HUNTS POINT INTERSTATE ACCESS IMPROVEMENT PROJECT – CONTRACT 3

PIN X731.65, Contract D900055

Addendum #8

July 22, 2022

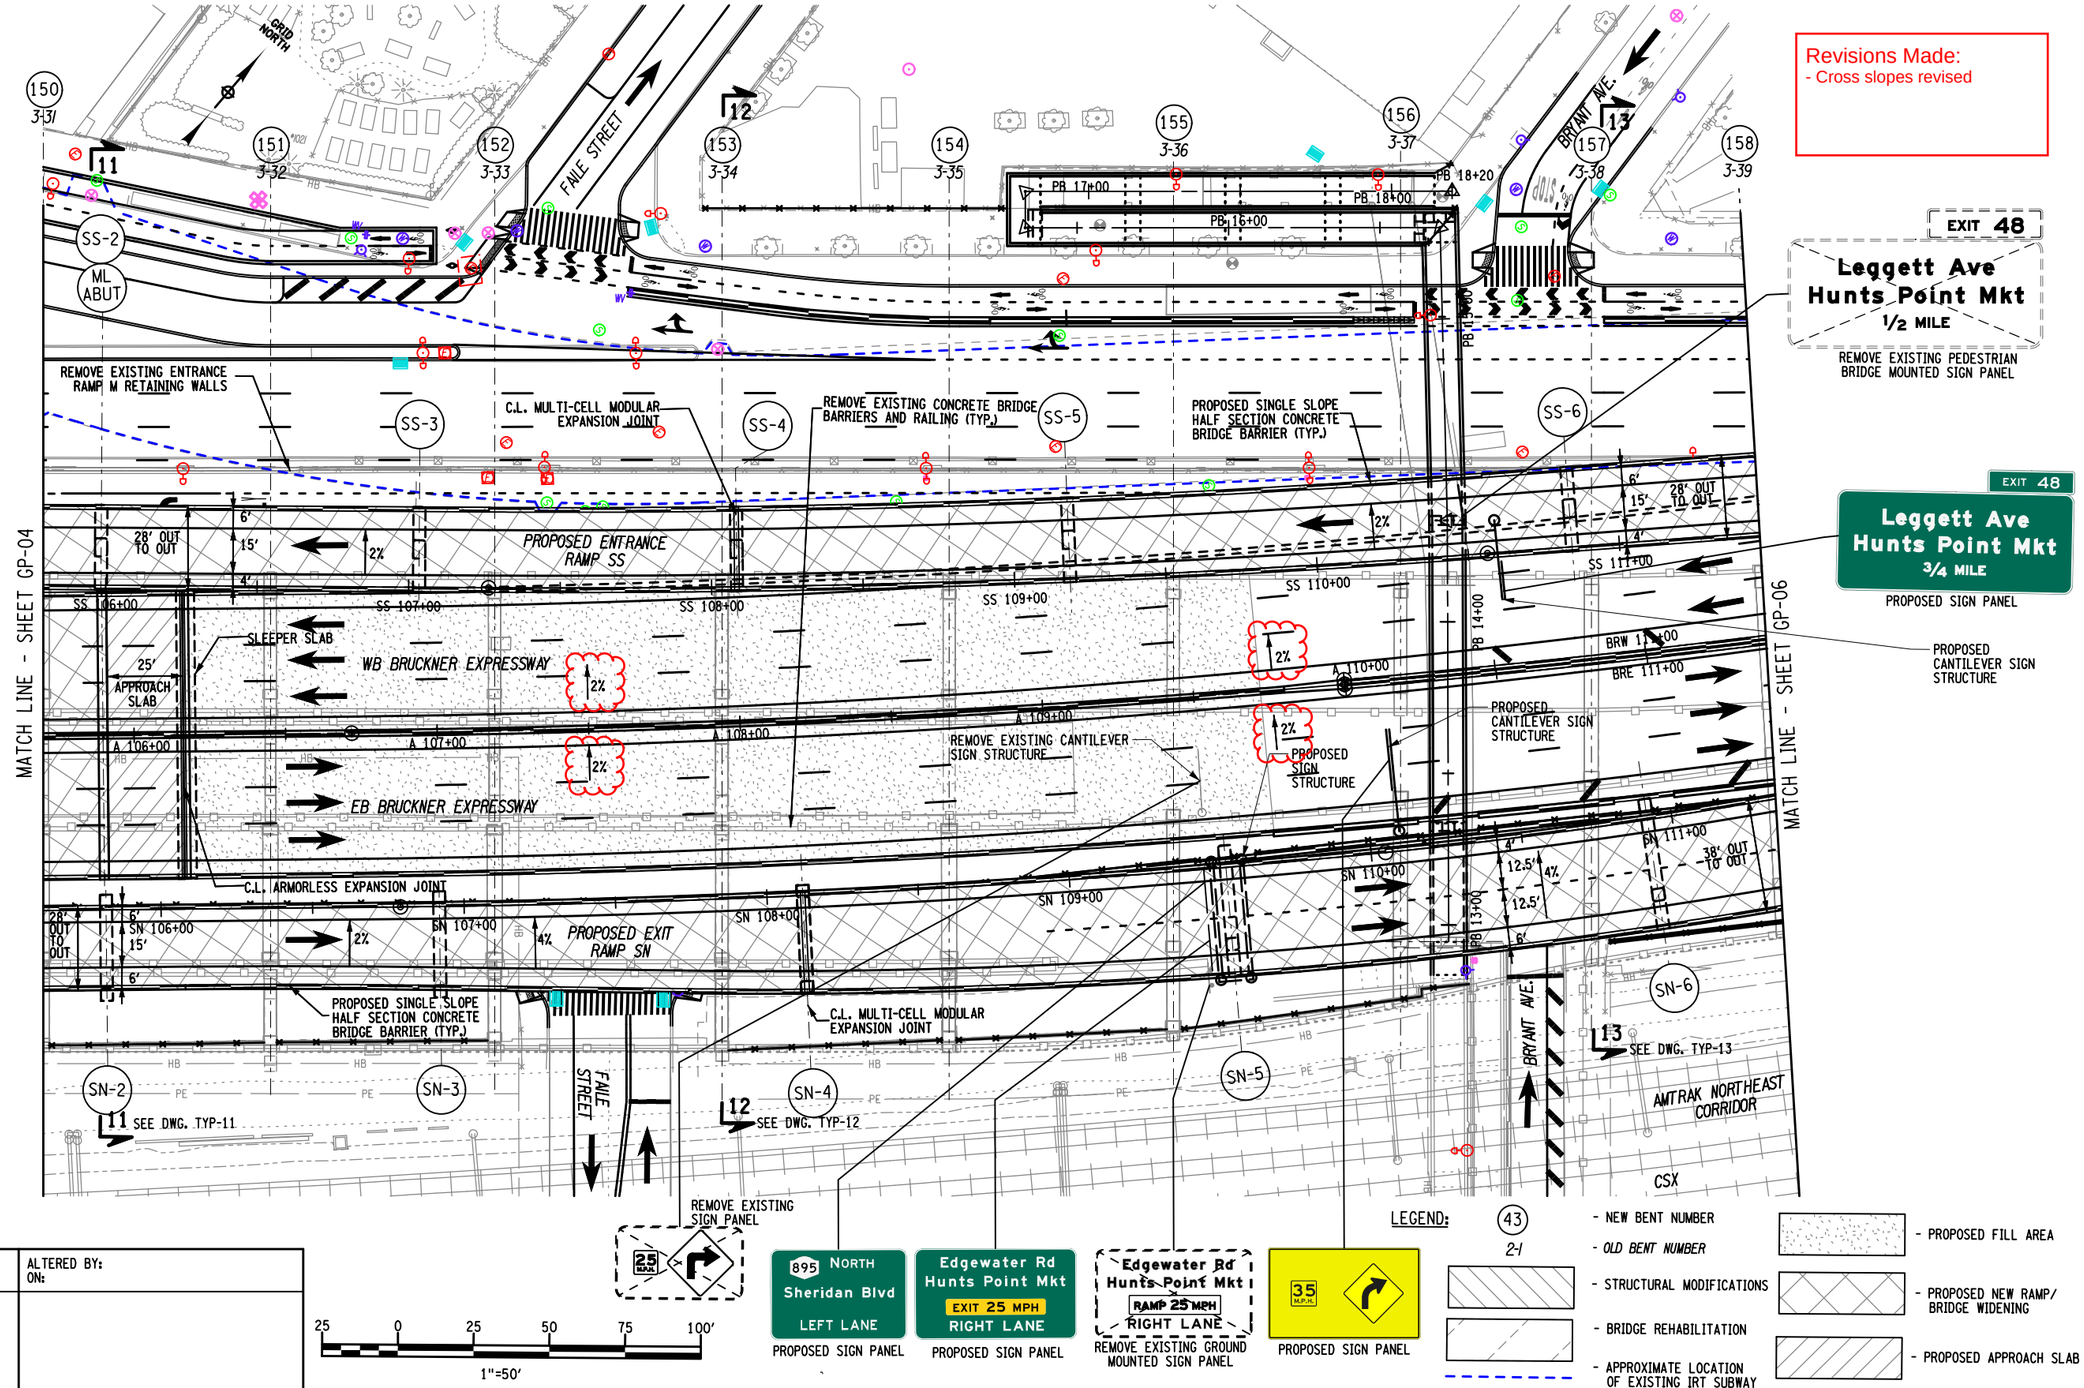
Revisions Made:
- Cross slopes revised

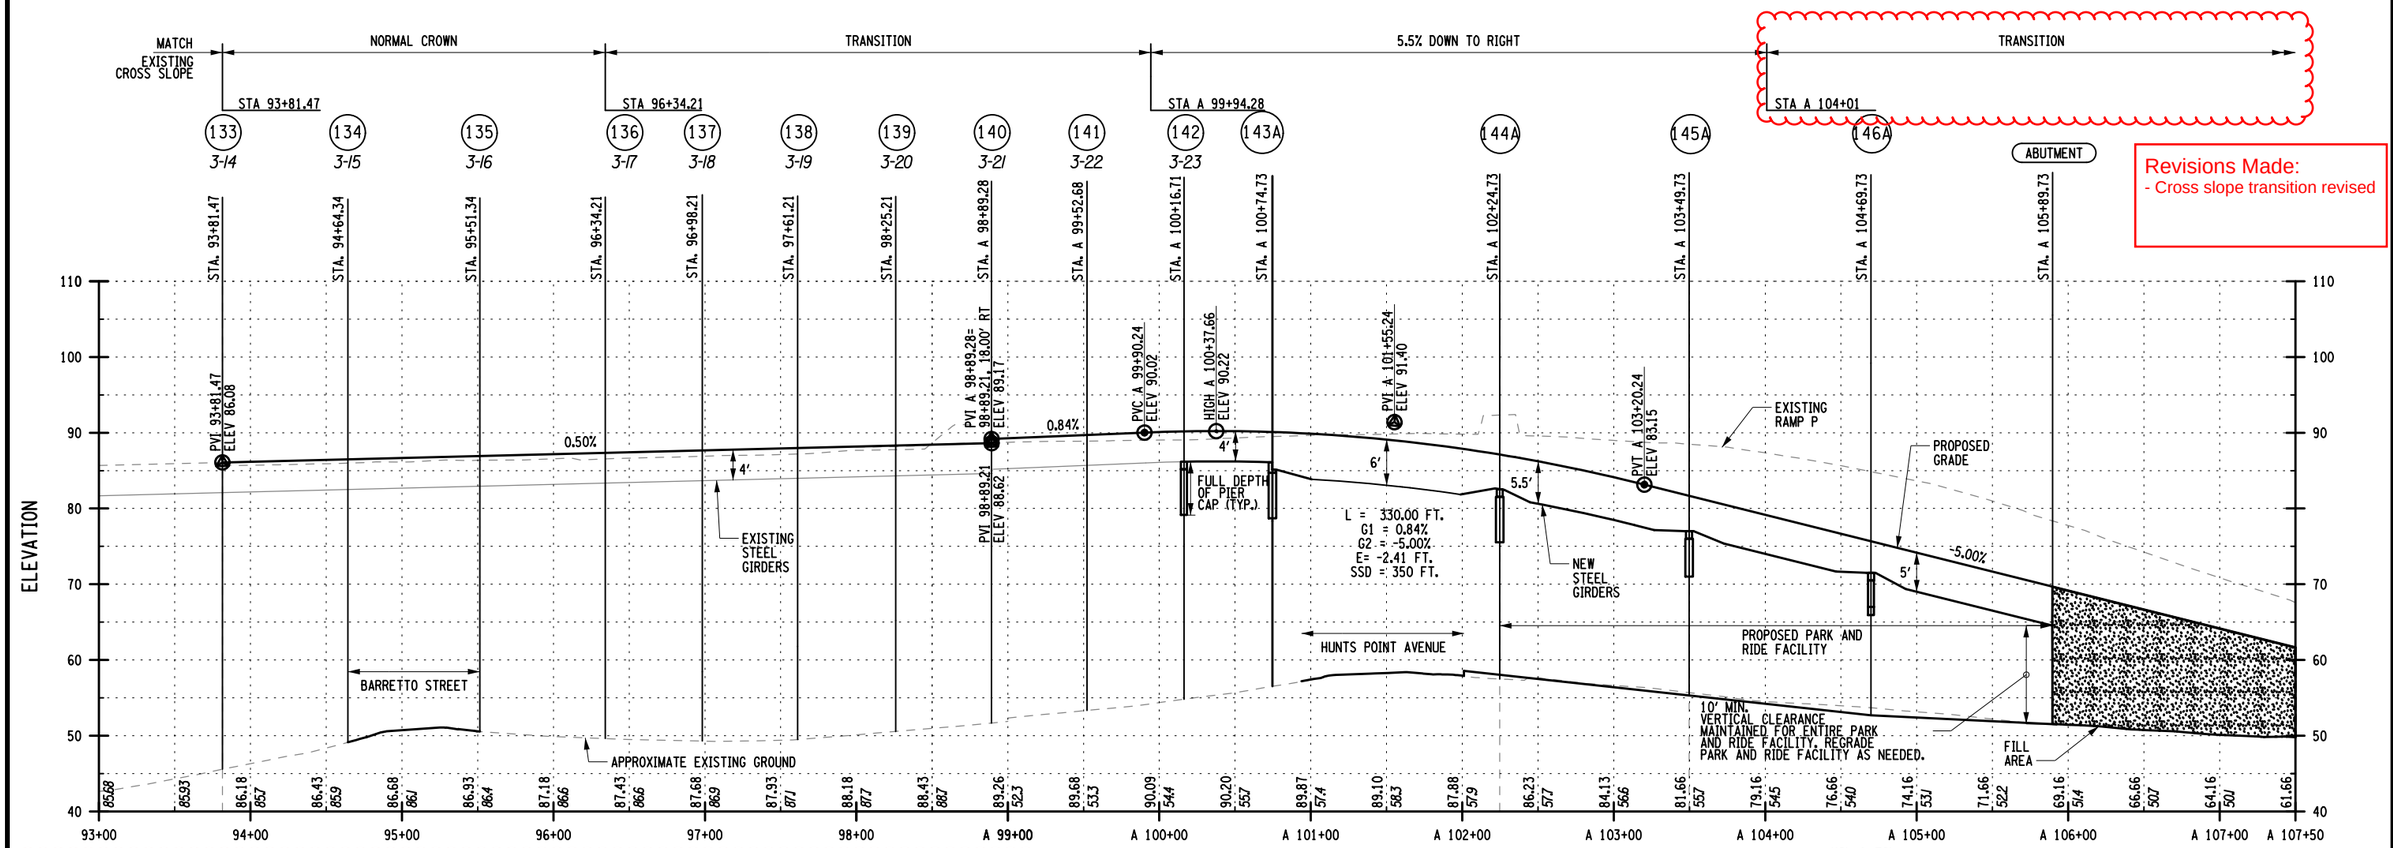
Revisions Made:
- Cross slope transition revised

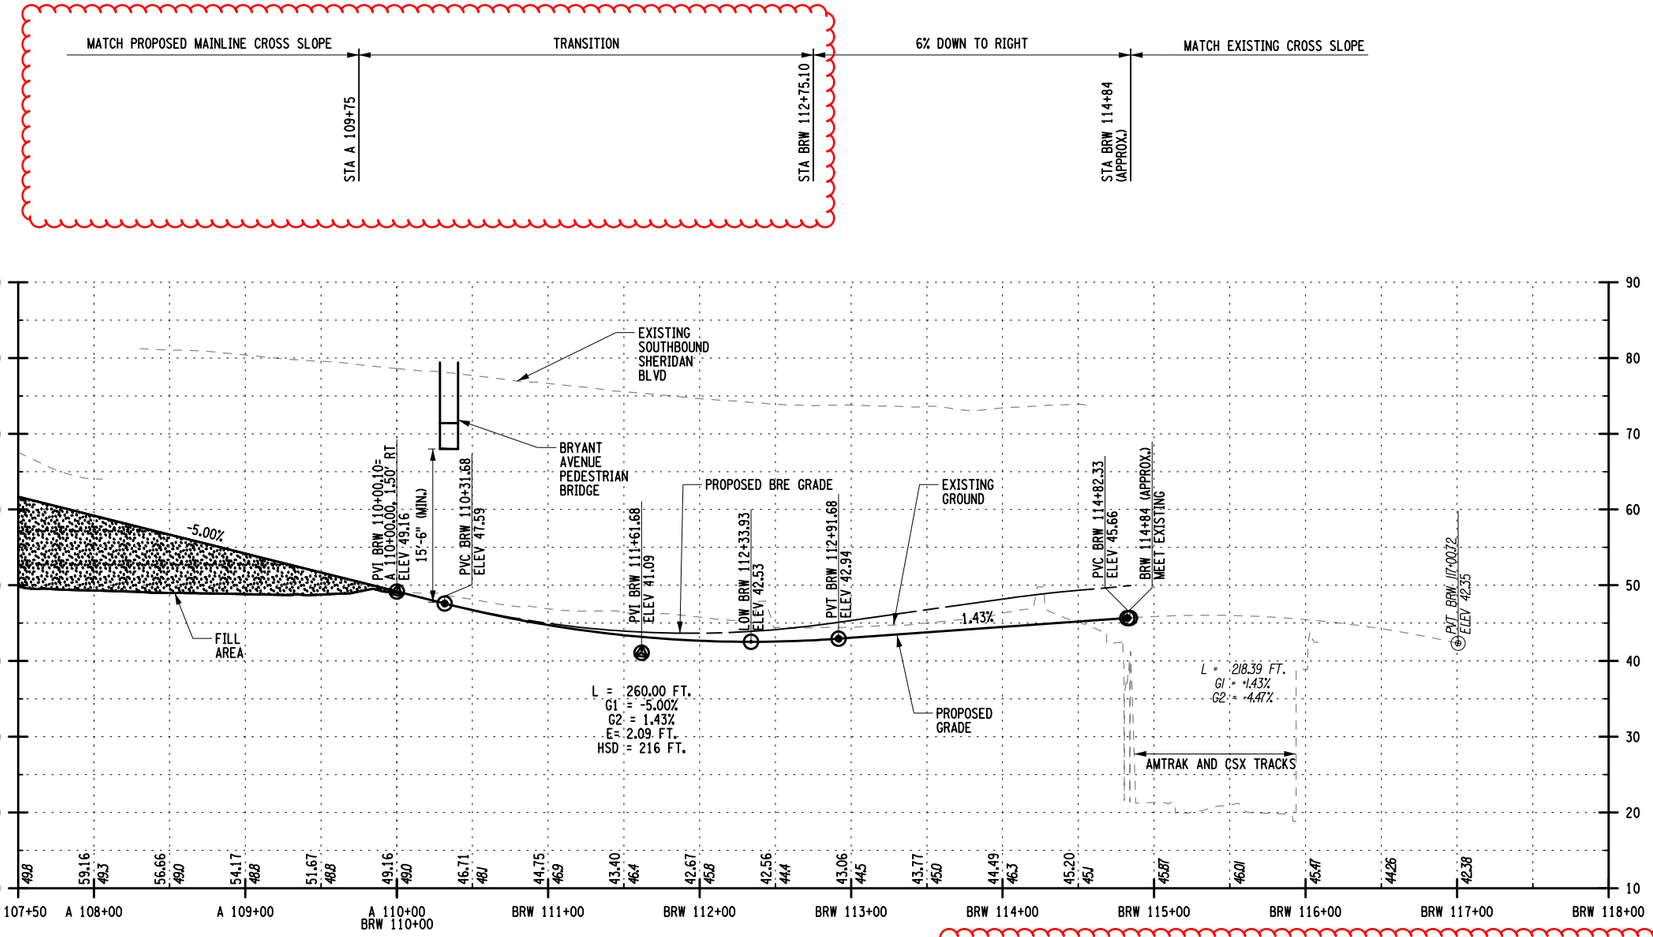
Revisions Made:
- Cross slope transition revised

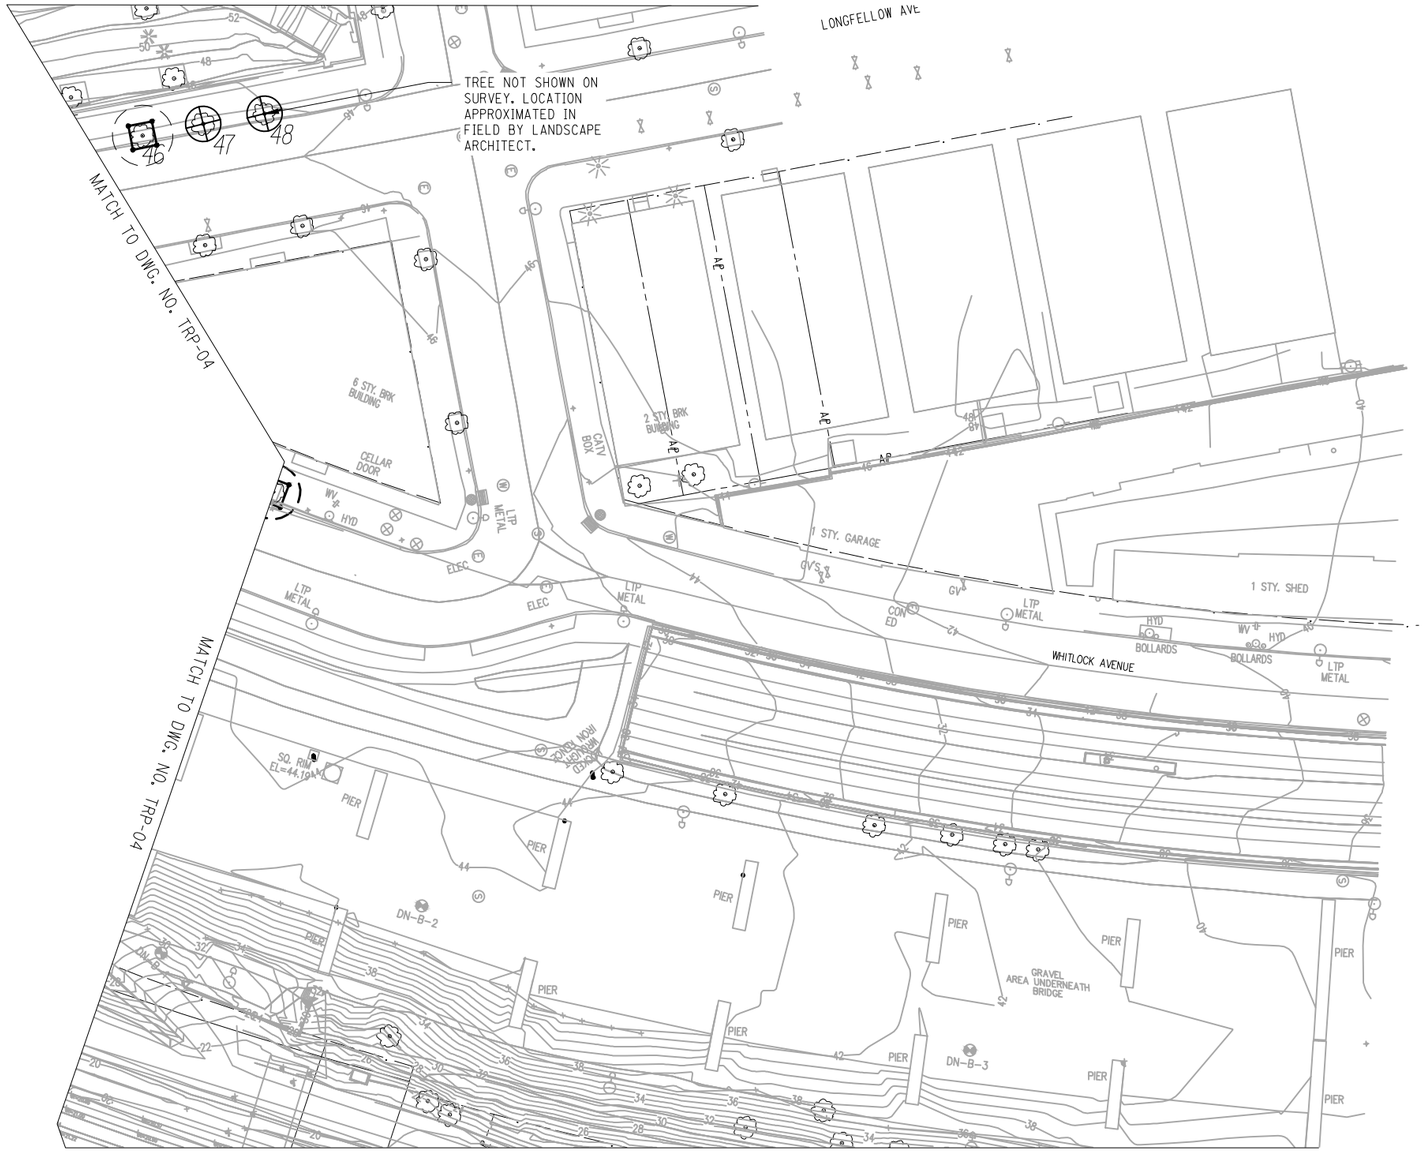
- Sheet view adjusted.

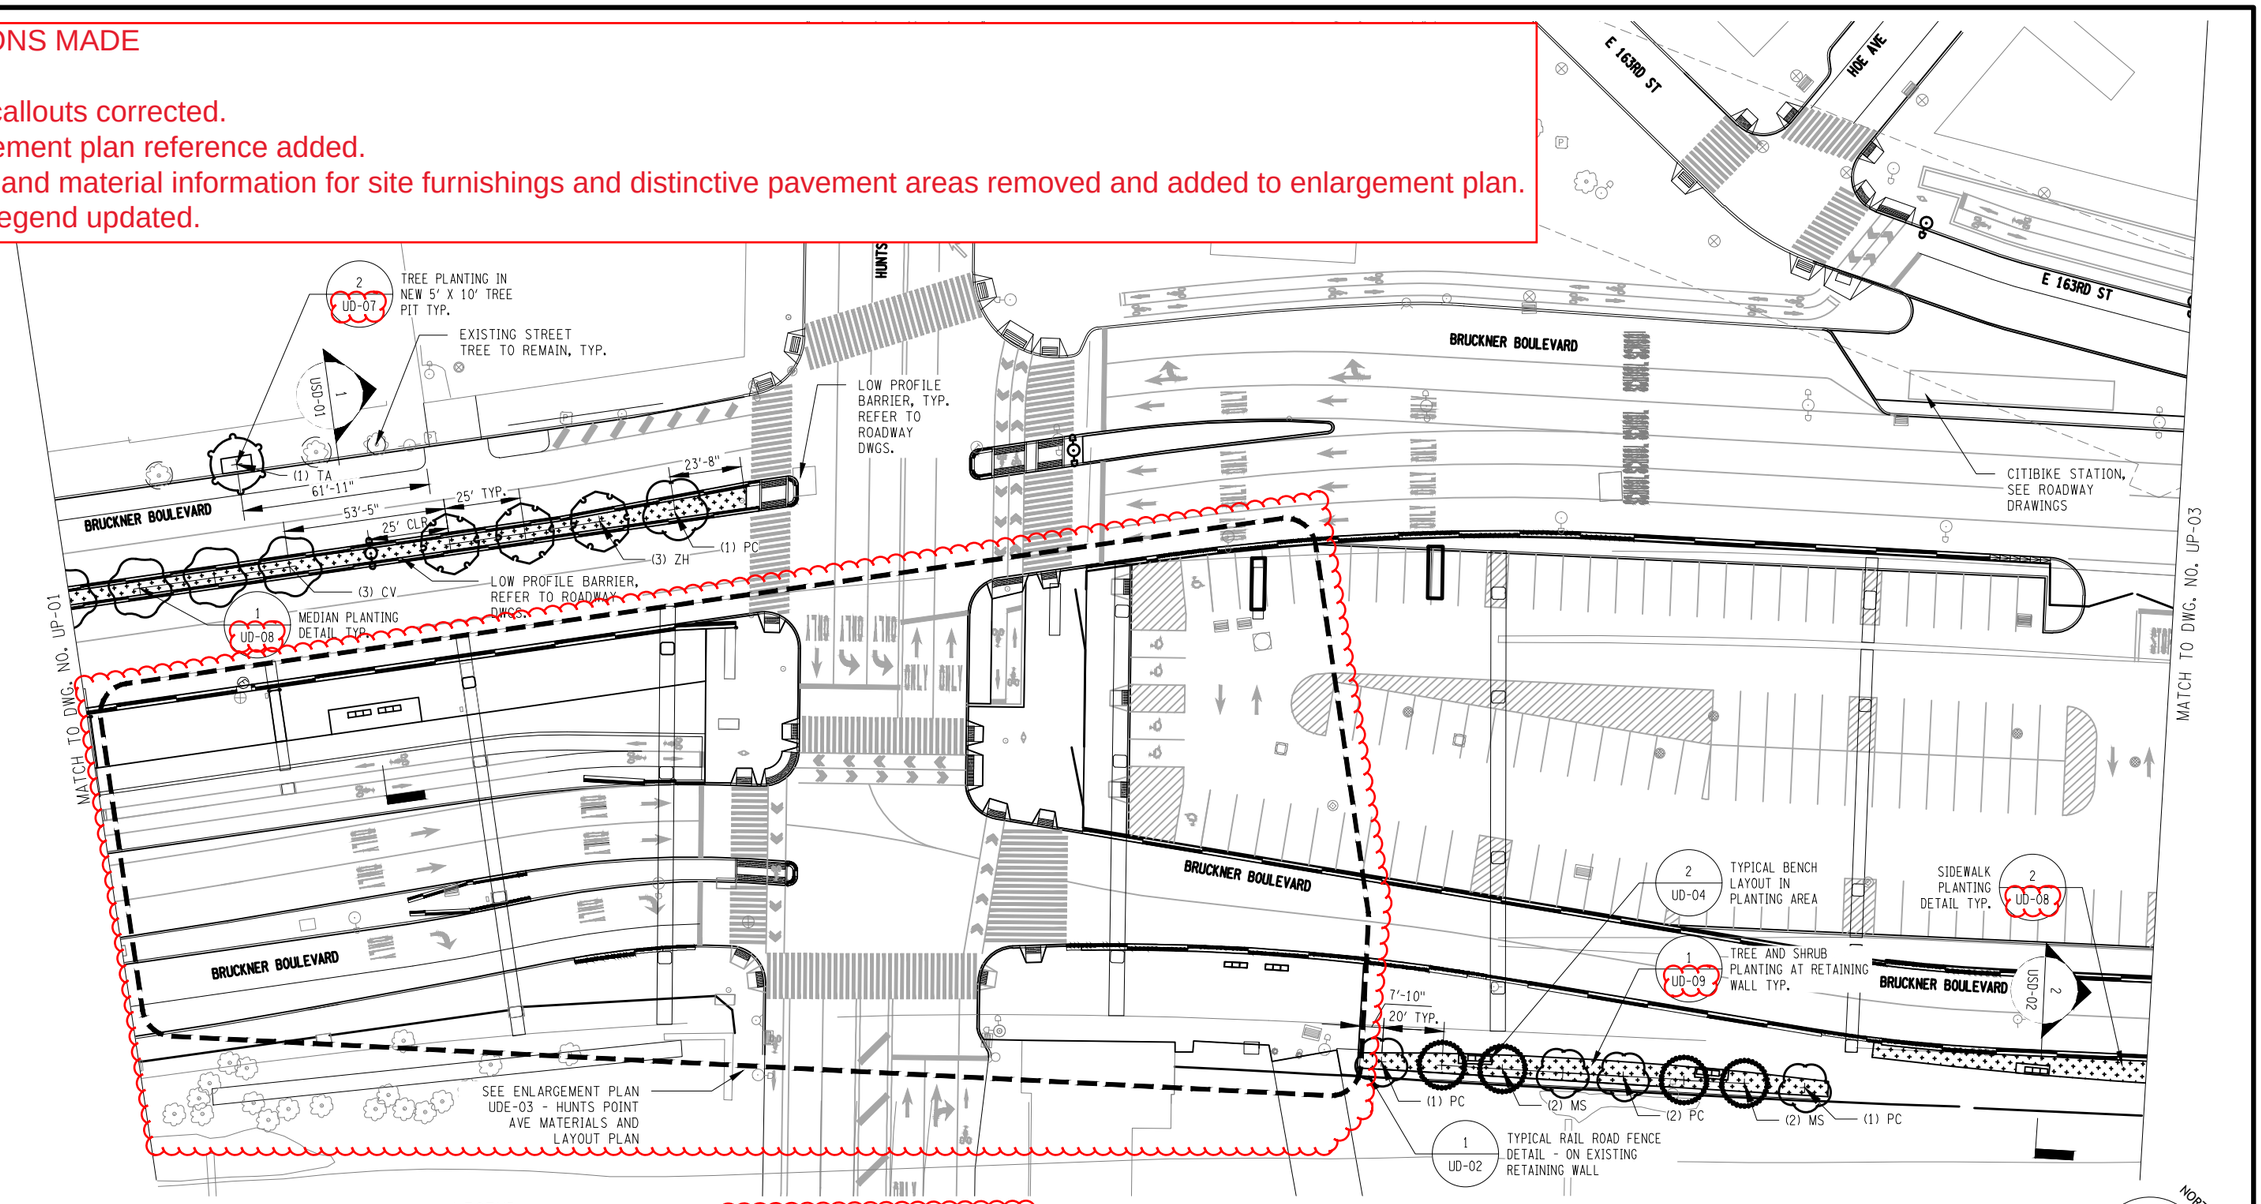
- Detail callouts corrected.
- Enlargement plan reference added.
- Layout and material information for site furnishings and distinctive pavement areas removed and added to enlargement plan.
- Sheet legend updated.
